RE: Register Number 202-1  
Ref: 202-1/Art14(2)(b)(ii) dated 17/01/05

Please find enclosed an original plus 2 paper copies and 11 CD-ROM copies of information requested for Article 14 Compliance for the above facility.

Seamus Kelly & Sons  
Proposed Site Drainage

Job No. C003587	Figure No. 2.6.1 (Rev. A)
Date. Feb. 2005

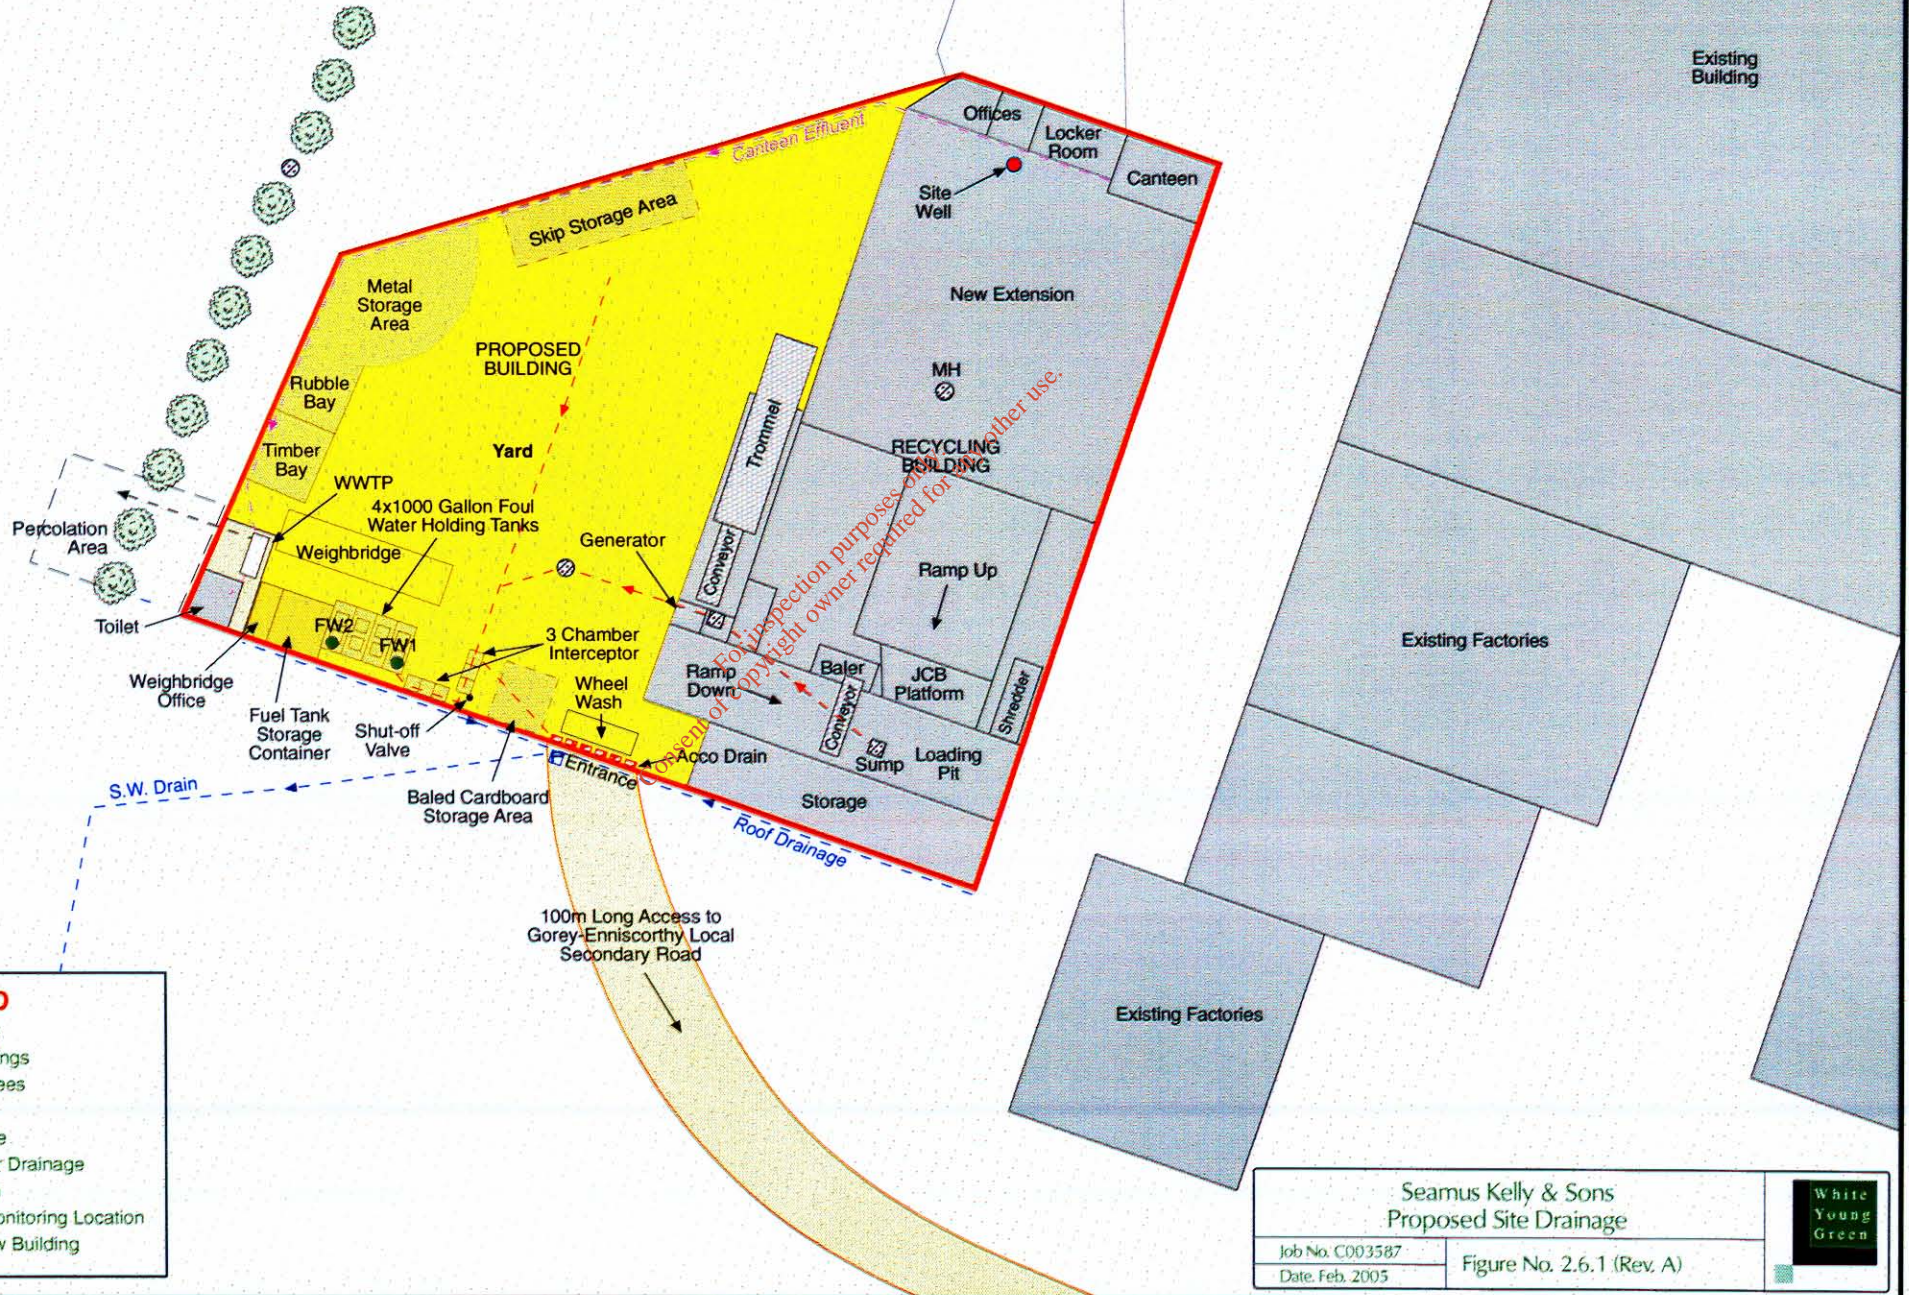
1 *Revised Figure No. 2.6.1 shows the surface water drainage in blue going to the drain at the site entrance however, documentation provided relating to the planning application states that the surface water is to be disposed of to existing surface water drain in centre of the existing yard. This proposal is supported in the site layout plan, which constitutes part of the planning application. Please clarify and revise Figure No. 2.6.1 accordingly.*

2 *Reproduce Figure No. 2.6.1 (site drainage) showing the precise location of the proposed wheelwash facility and corresponding drainage within the site.*

We confirm that earlier plans for the site including those submitted as part of the planning application showed roof drainage directed to a drain in the centre of the existing yard. However, it is considered that a superior method of discharging the roof drainage to the local storm water drain is to collect the roof drainage in the roof guttering and direct it down the sides of the building via downpipes directly to the storm water drain located just outside the site entrance. The roof drainage will not be in contact with any contaminated surfaces and will comprise pristine rainfall and will not require any treatment in silt traps or oil interceptors prior to its discharge to the storm drain.

The drain in the centre of the yard will be maintained and used for internal floor drainage inside the proposed new building. This drain will collect any leachate or floor washdown water generated inside the building and will be directed through the two 3-chamber interceptors and from there to the underground foul water storage tanks.

Figure 2.6.1 is attached in Annex 1. This shows the location of the proposed wheel wash just inside the site entrance. All trucks will be required to pass through the wheelwash when entering or exiting the site.

Job No. C003587	Figure No. 2.2.1
Date: Oct. 2004

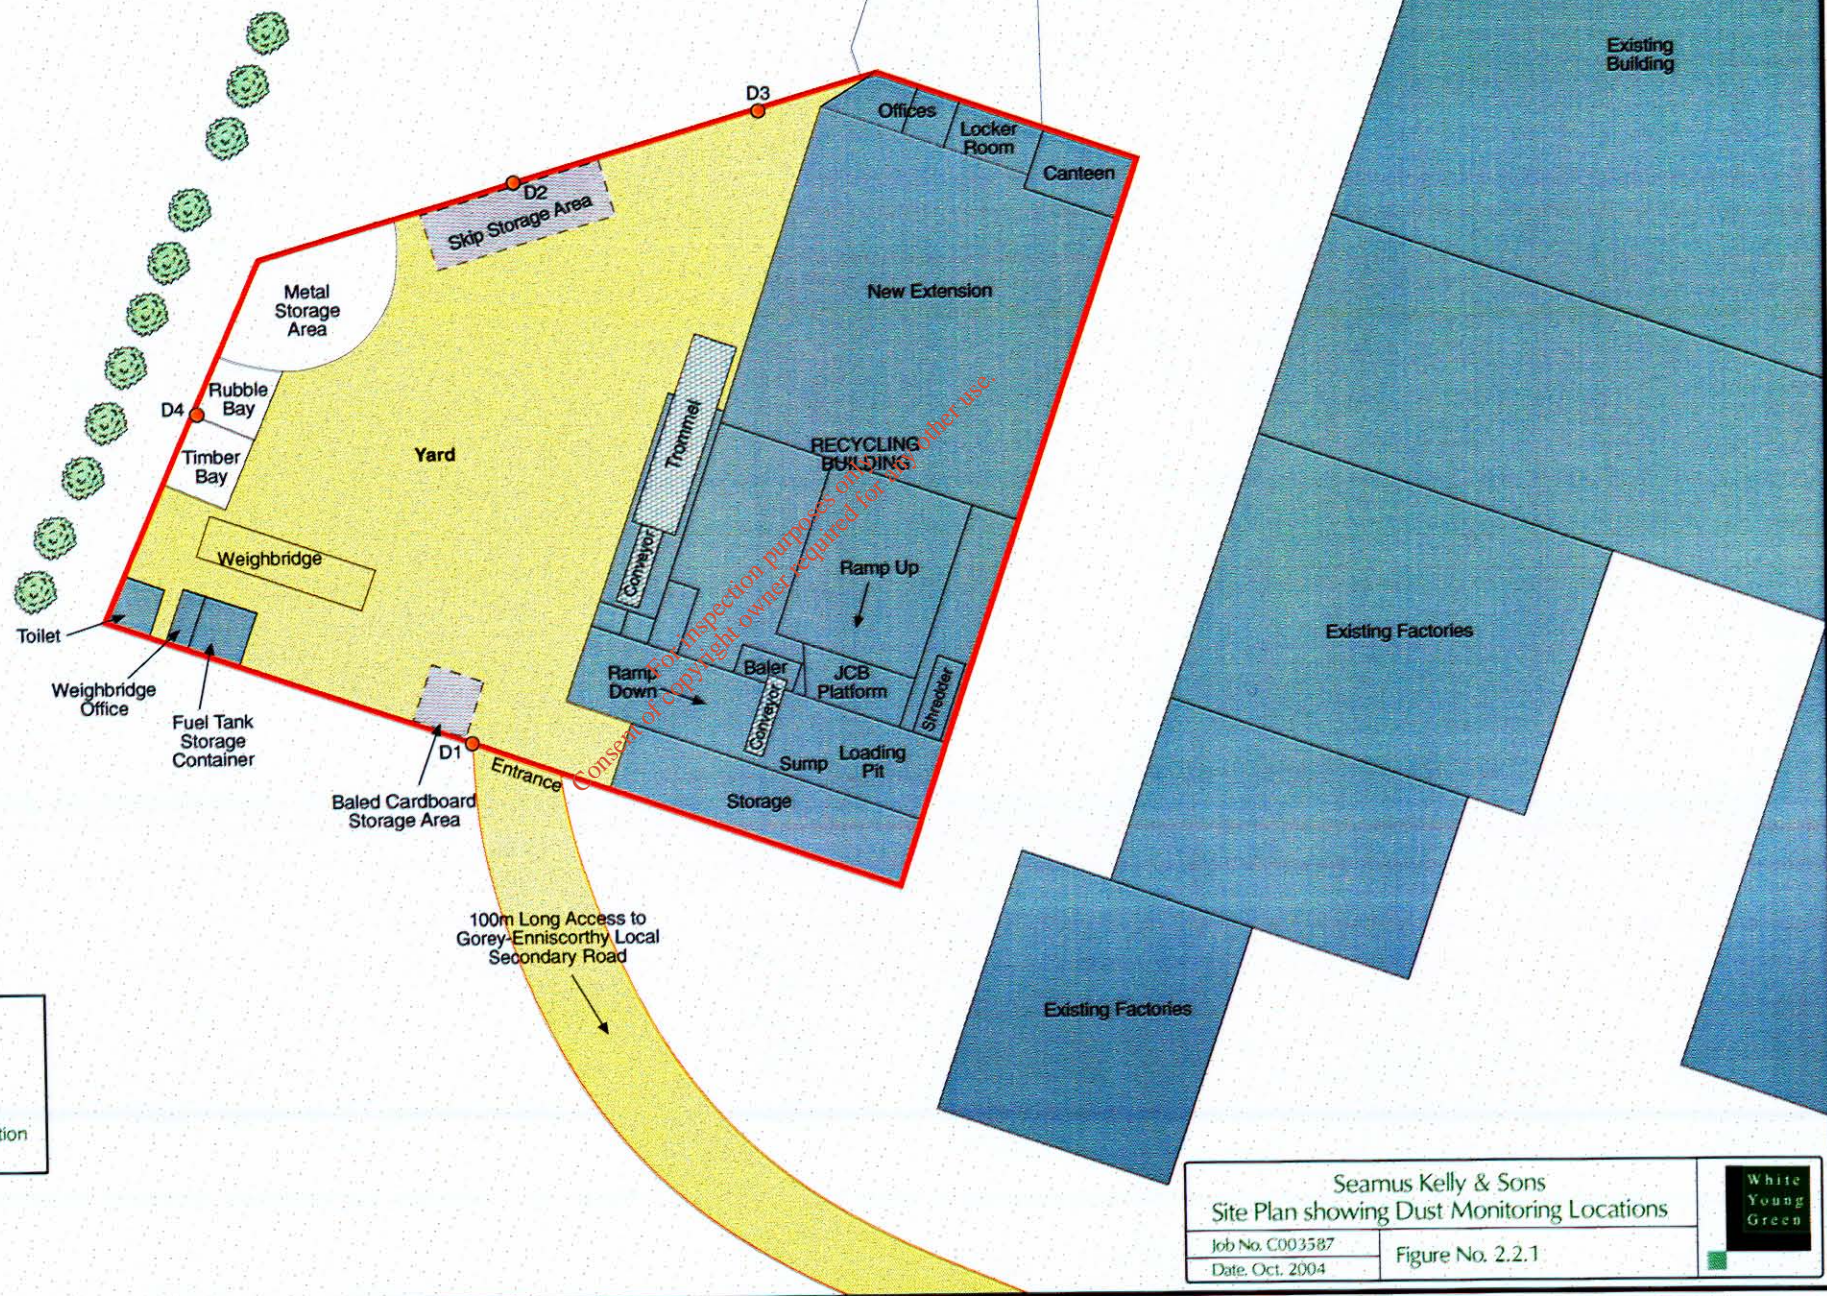
Please provide Figure No. 2.2.1 showing the location of dust monitoring gauges D1, D2 and D4.

Please see Figure No. 2.2.1 enclosed in Annex 1 of this submission.
